REVISIONS	
NAME	DATE
ADDENDUM NO. 1	12/23/11

ILLINOIS DEPARTMENT OF TRANSPORTATION
 F.A.P. ROUTE 307 (ILLINOIS ROUTE 64)

ROADWAY LIGHTING PLAN
 STA. 3287+00 TO STA. 3312+00

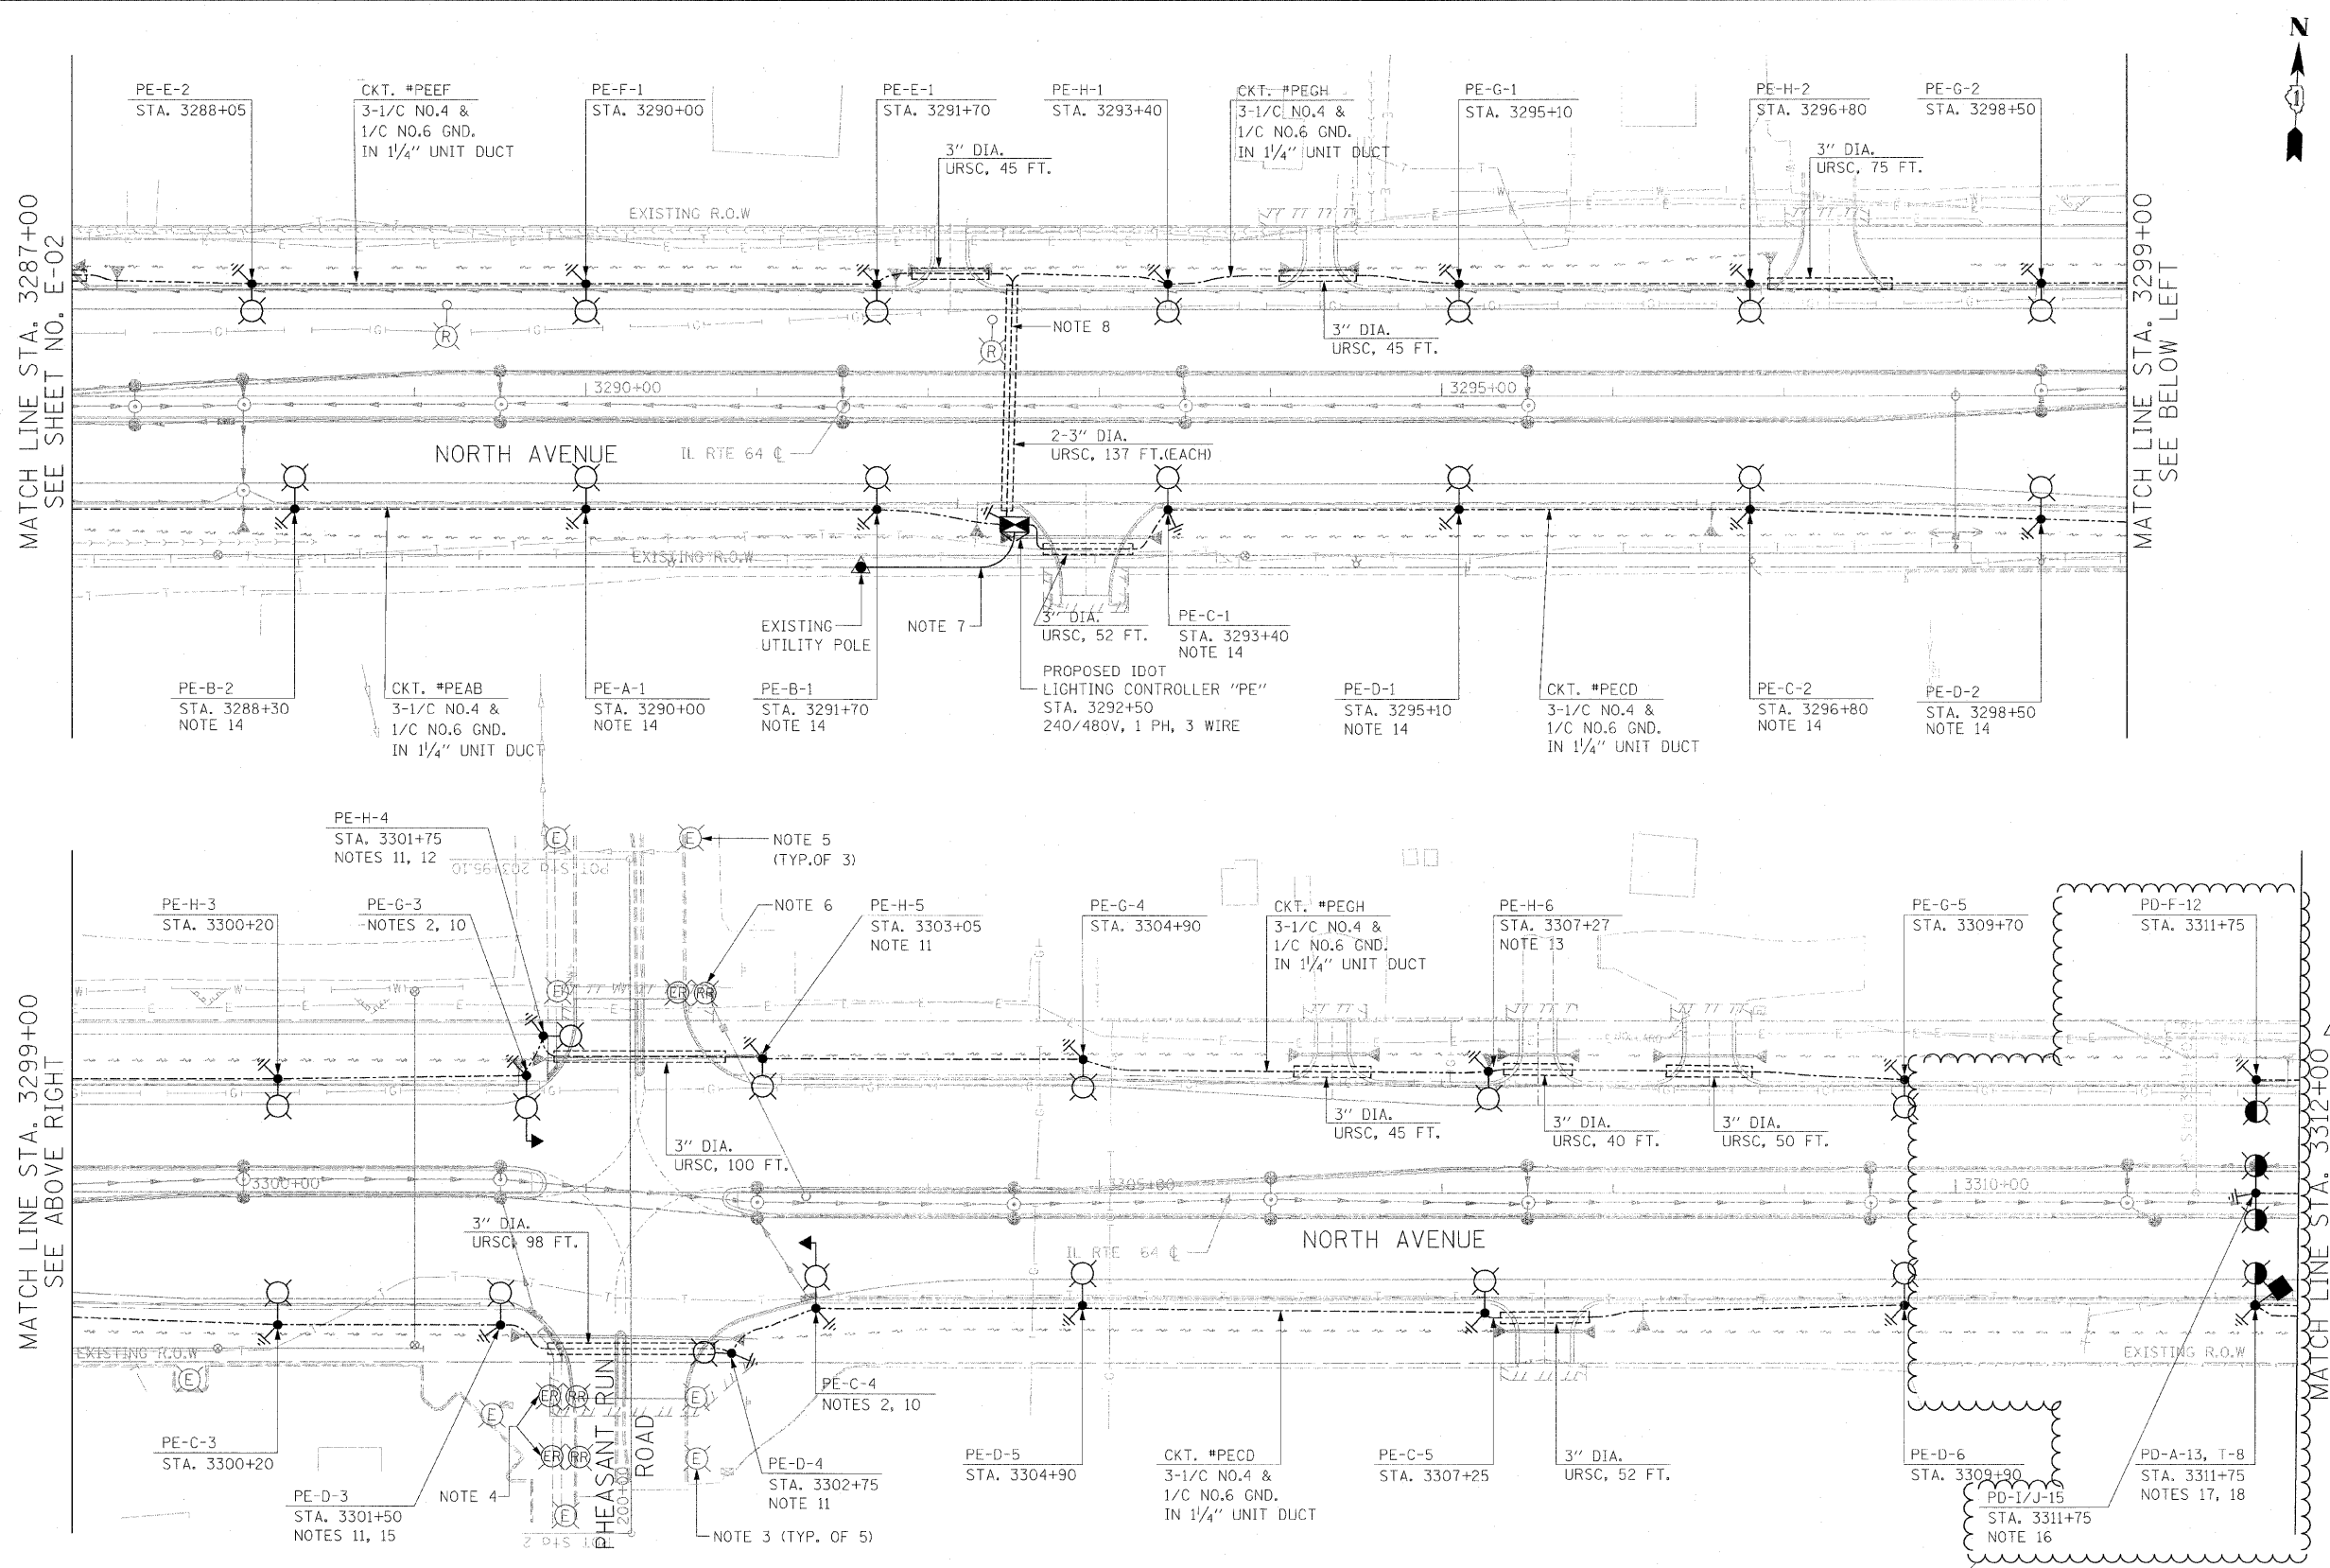
18. PROVIDE AN AVIATION OBSTRUCTION WARNING LUMINAIRE. THE OBSTRUCTION LUMINAIRE SHALL BE OPERATED AT 240 VOLTS. SEE SHEET E-12 FOR AVIATION OBSTRUCTION WARNING LUMINAIRE MOUNTING DETAILS.
